寄件者: Jeffrey Lam [REDACTED]  
寄件日期: 2024年04月08日星期一 18:20  
收件者: William Shu Tai WONG/PLAND  
主旨: A/NE-TKLN/79  
附件: Revised Planning Statement pages 2, 3, 7, 13, 14.pdf; Timber- Swept Path Analysis Revised.pdf; Local Access Photo.pdf; Response to Comments- TKLN79-2.pdf; Traffic Survey- Revised.pdf; Application Form Revised Page 6.pdf

## Response to Comments

PROPOSED TEMPORARY WAREHOUSE FOR STORAGE OF CONSTRUCTION MATERIAL FOR A PERIOD OF THREE YEARS IN “RECREATION” ZONE

VARIOUS LOTS OF D.D. 80, TA KWU LING NORTH, NEW TERRITORIES

Drawing No:  
**Plan 3**

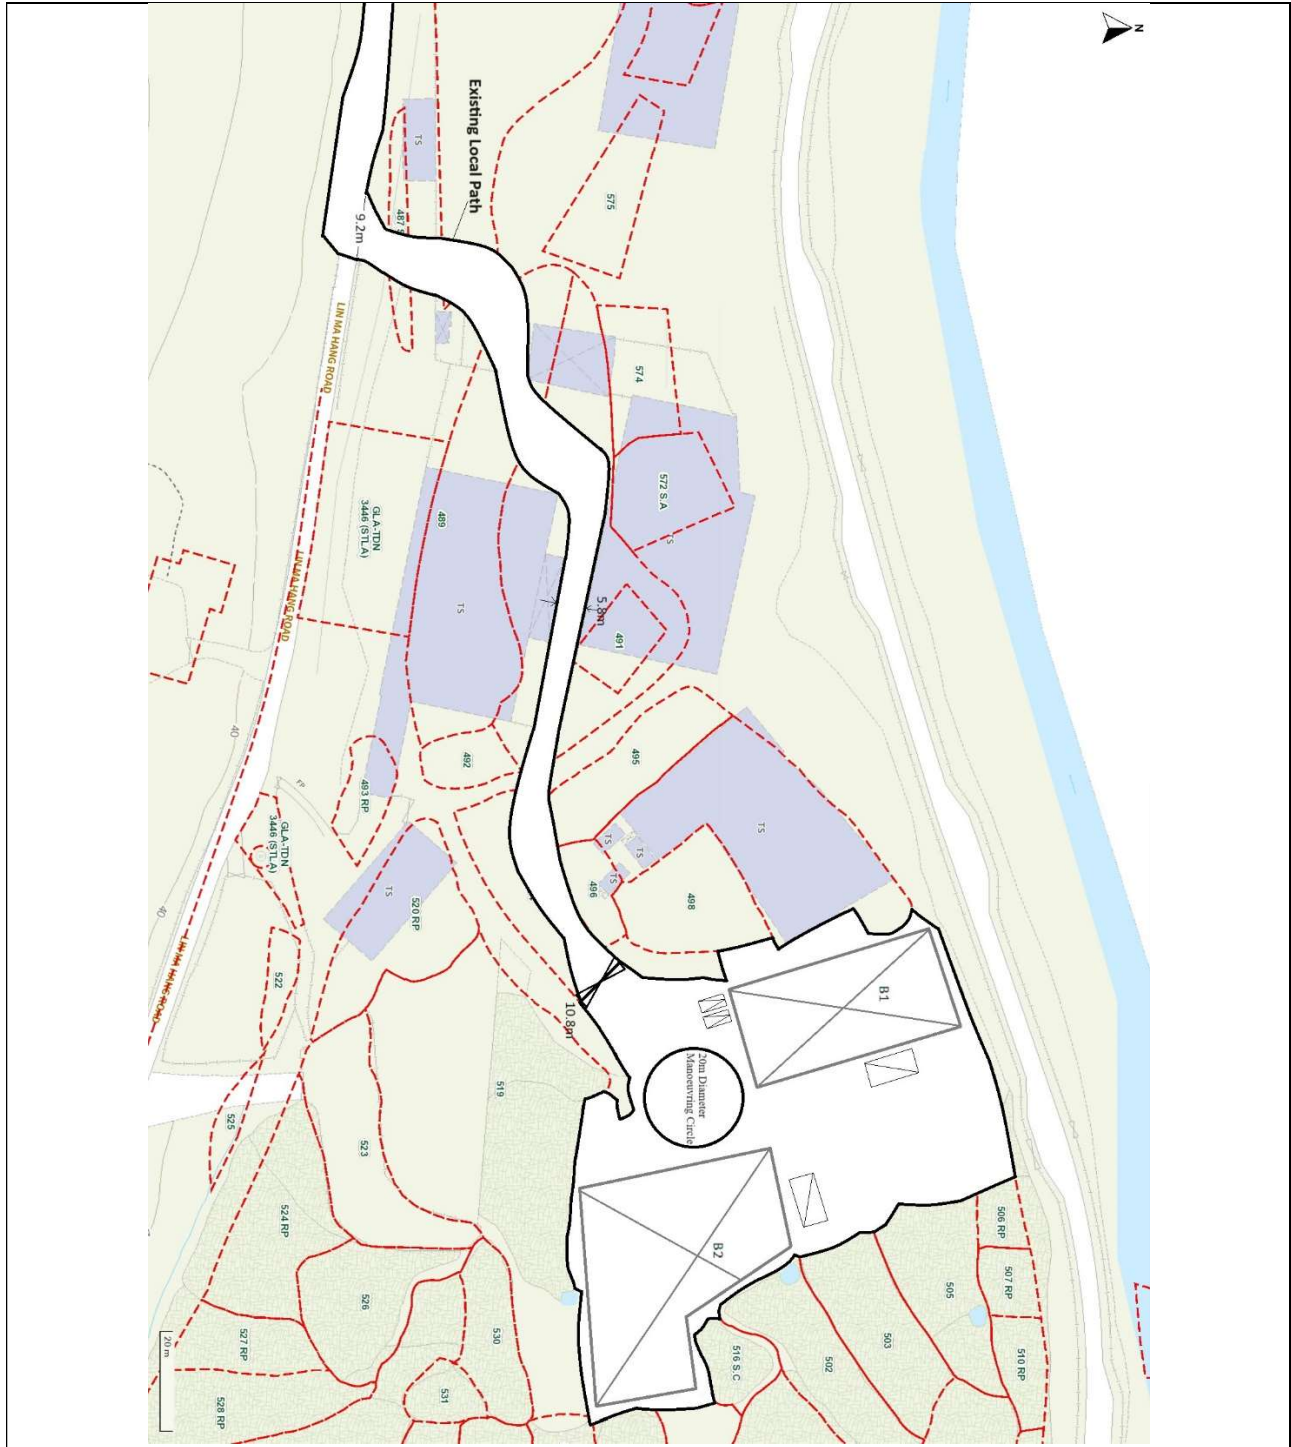
Departmental Comments	Applicant’s Response
<p><u>Comments from Transport Department</u></p> <ul style="list-style-type: none"> <li>The traffic count survey should have also conducted on a typical Saturday, as Lin Ma Hang road is busier during weekend due to heavier public access and traffic demand to the Heung Yuen Wai Boundary Control Point. The traffic count to be conducted on Saturday shall be from 8am to 7pm</li> </ul>	<p>Noted. Please find revised traffic survey. A traffic count survey was conducted on Saturday, April 6th, 2024, from 7am to 8pm to account for the heavier public access and traffic demand of the weekend.</p>
<ul style="list-style-type: none"> <li>The applicant should advise the width of the vehicular access (ingress and egress points).</li> </ul>	<p>The vehicular access has been revised to be an existing single lane 2-way local access with 9.2m at the ingress and 10.8m at the egress.</p>

4.2.2 Two structures of one story (not more than) 7m in height are proposed at the Site for warehouse with total GFA 2,222m<sup>2</sup> (about) (**Plan 3**).
